## ORIGINATION FORM

Proposed Revisions to a Standard Plans Index  
(Please provide all information — Incomplete forms will be returned)

Index Number: 548-020  
Sheet Number (s): Sheets 1 of 1  
Index Title: MSE Retaining Wall Systems - Permanent

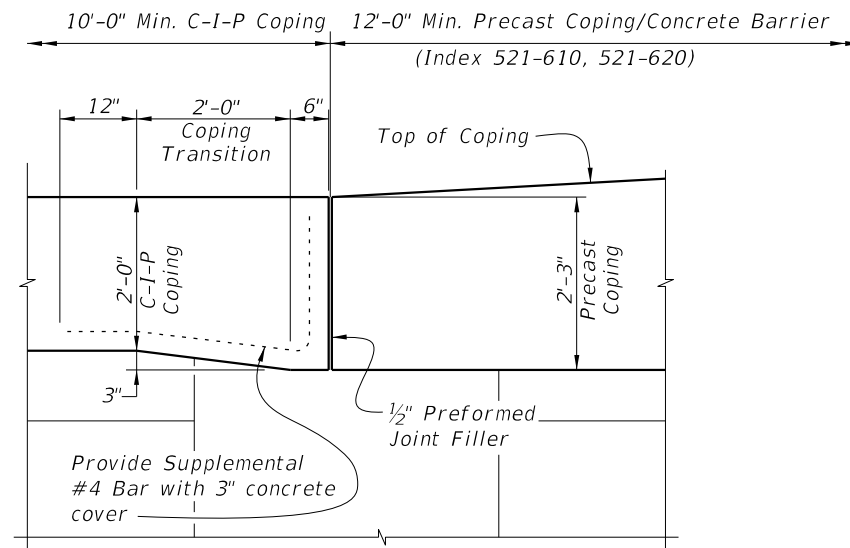
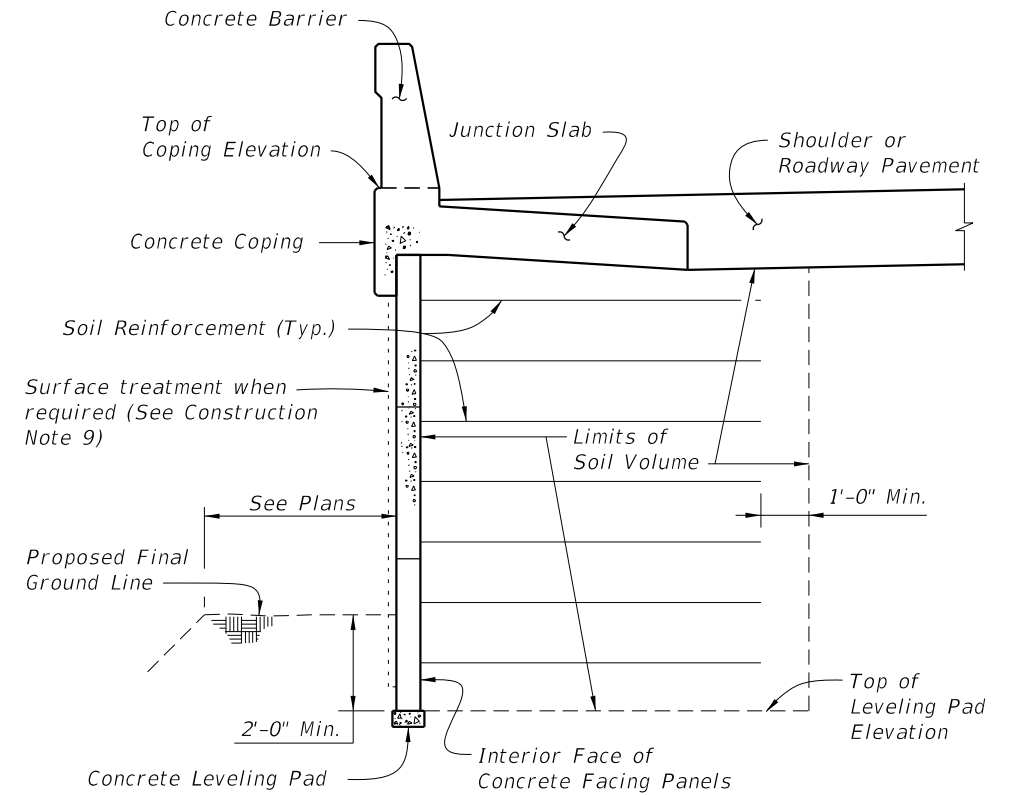
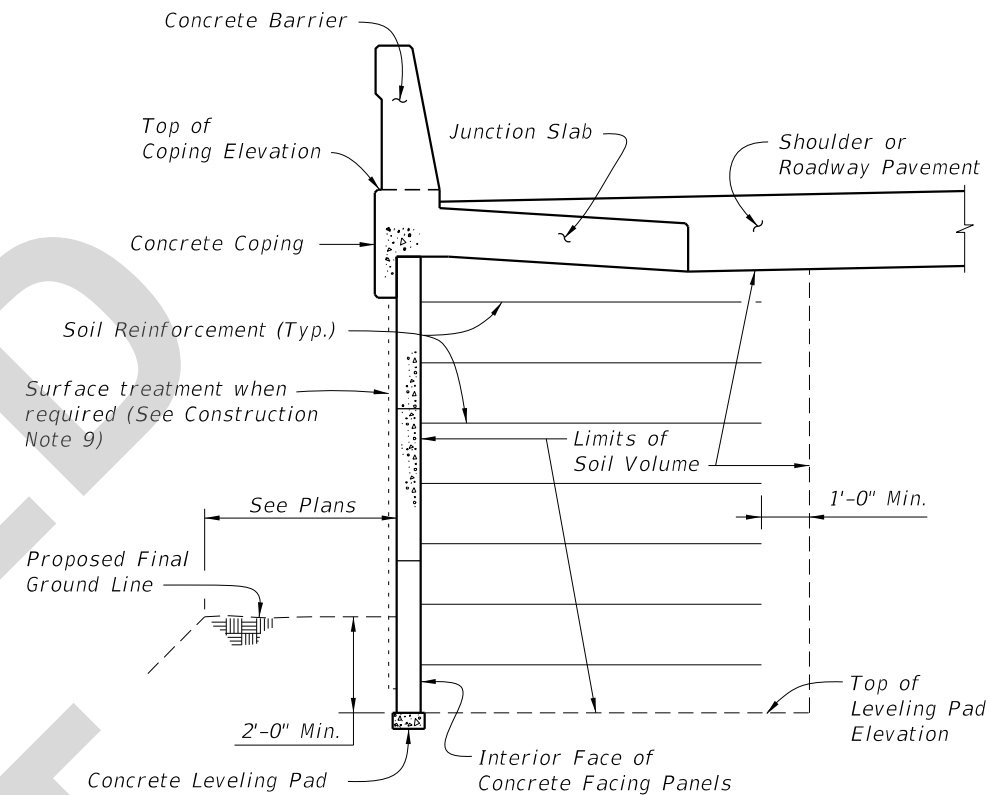
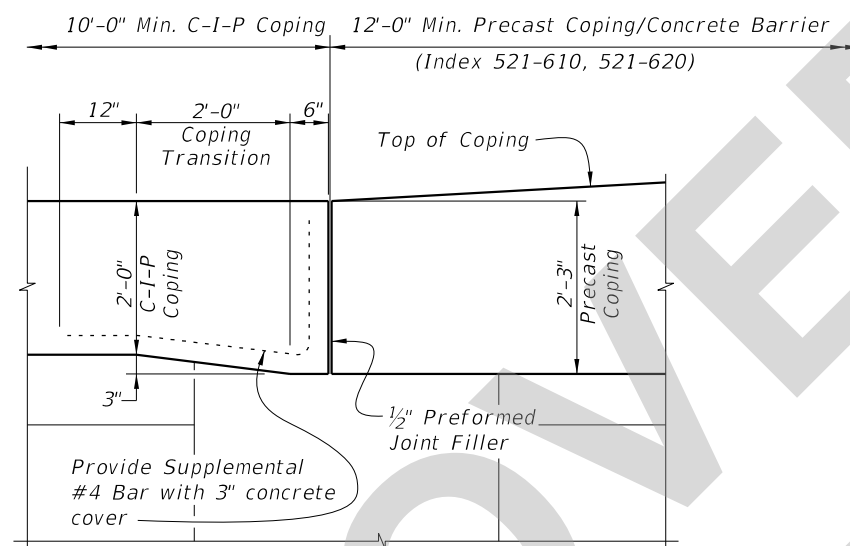
Removed alternative allowable wall type 2E from 2D.

Type 2E walls may not be able to accommodate the more aggressive environment condition that the type 2D is designated for per Dongming White.

Remove checkmark

| Applicable FDOT Wall Type * | Durability Requirements (Carbon-Steel Reinforcing) |                           |                        | Durability Requirements (FRP Reinforcing) |                           |                        | Soil Reinforcement Type | Other Allowable FDOT Wall Types |    |    |    |    |    |
|-----------------------------|--|---------------------------|------------------------|---|---------------------------|------------------------|-------------------------|---------------------------------|----|----|----|----|----|
| Type 2D                     | 3  | IV                        | Yes                    | 2   | IV                        | No                     | Metal                   |                                 |    |    |    |    | ✓  |
